Service Bulletin

DASHBOARD UPPER PANEL STICKY SURFACE AND/OR WARPING

Bulletin No: 09-038/14

2010-2013 Mazda3 vehicles with VINs between:

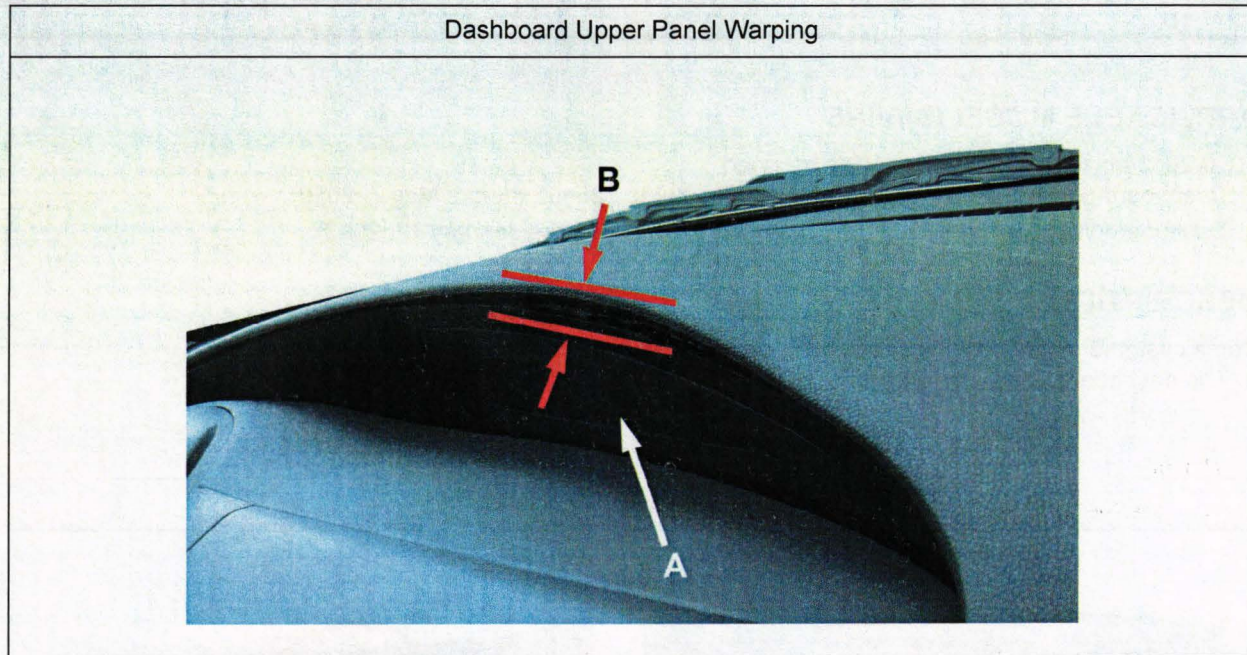
- b. The dashboard upper panel just above the information display (A) is warping, generating a gap (B).

Customers having this concern should have their vehicle repaired using the following repair procedure.
